## PIC16C72 Rev. A Silicon Errata Sheet

The PIC16C72 (Rev. A) parts you have received conform functionally to the Device Data Sheet (DS39016A), except for the anomalies described below.

**FIGURE 1: WRITES TO TIMER1 (EXTERNAL CLOCK / OSCILLATOR MODE)**

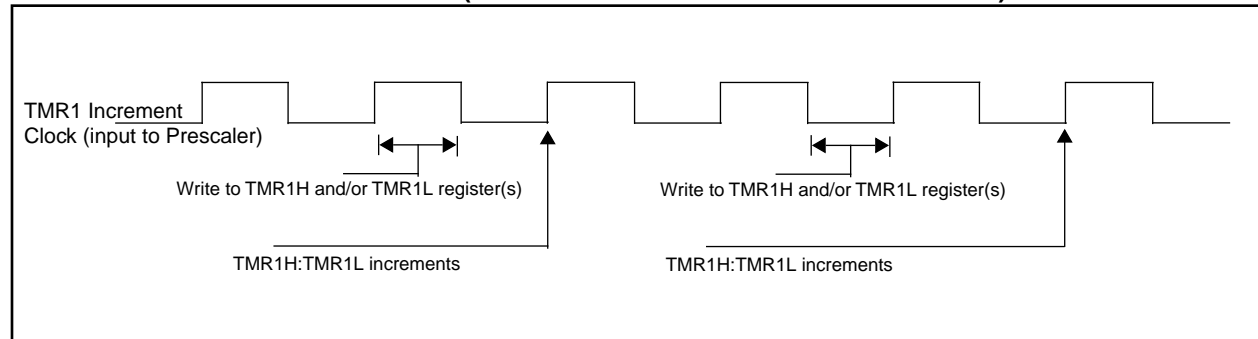
- a) The operation of Timer1 needs some clarification when the timer registers are written when the TMR1ON bit is set.

The internal clock signal that is the input to the TMR1 prescaler affects the incrementing of Timer1 (TMR1H:TMR1L registers and the Timer1 prescaler). When the Timer1 registers are NOT written, the Timer1 will increment on the rising edge of the TMR1 increment clock.

When the TMR1H and/or TMR1L registers are written while this clock is high, TMR1 will increment on the next rising edge of this clock.

When the TMR1H and/or TMR1L registers are written while this clock is low, TMR1 will not increment on the next rising edge of this clock, but must first have a falling clock and the rising clock for TMR1 to increment.

Figure 1 shows the two cases of writes to the TMR1H and/or TMR1L registers. Due to the  $V_{IH}$  and  $V_{IL}$  thresholds on the oscillator/clock pins, external Timer1 oscillator components, and external clock frequency, the Timer1 increment clock may not be of a 50% duty cycle.

The TMR1 increment clock is out of phase of the T1OSO/T1CKI pin by a small propagation delay.
